# Proposed Amendments to the Canada Olympic Park and Adjacent Lands Area Structure Plan

1. The Canada Olympic Park and Adjacent Lands Area Structure Plan attached to and forming part of Bylaw 1P2005, as amended, is hereby further amended as follows:
  - (a) Throughout the document, delete the term “Commercial Main Street” and replace with “Main Street” wherever it appears.
  - (b) In Section 3.0 Strategy, 3.1 Guiding Principles, delete the last bullet and replace with the following:

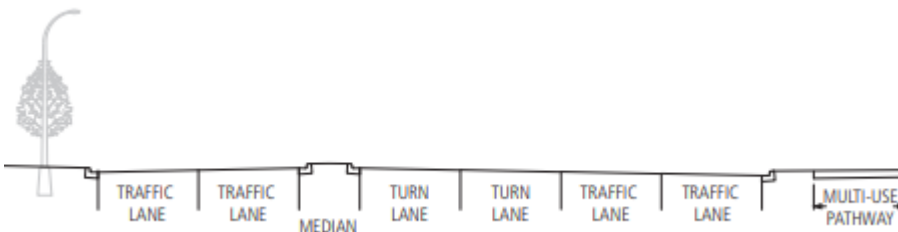
- (cc) In Section A.5 Built Form, A.5.2 Built Form, (3) Prominent Building Design and Review, delete guidelines (d)(ii) and (d)(iii) and replace with the following:

“(iii) as per the above figure, prominent buildings may have a minimum 6.0 metre setback from the edge of the podium above the sixth storey.”

**Street cross-section B: Canada Olympic Drive SW**

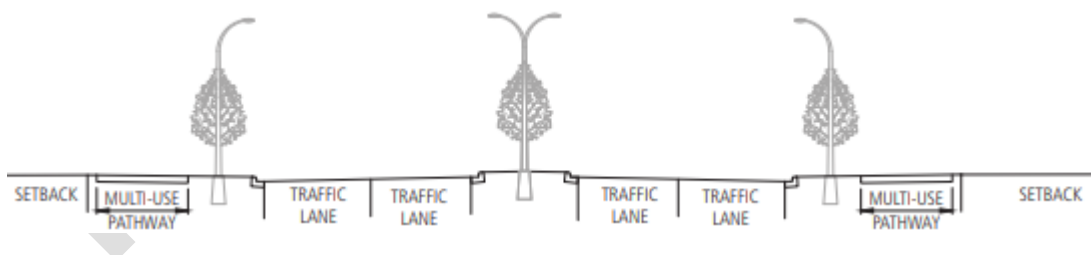
- (gg) In Section A.5 Built Form, A.5.4 Street Cross-Sections, delete Street cross-section A, B, C and D figures and replace with the following:
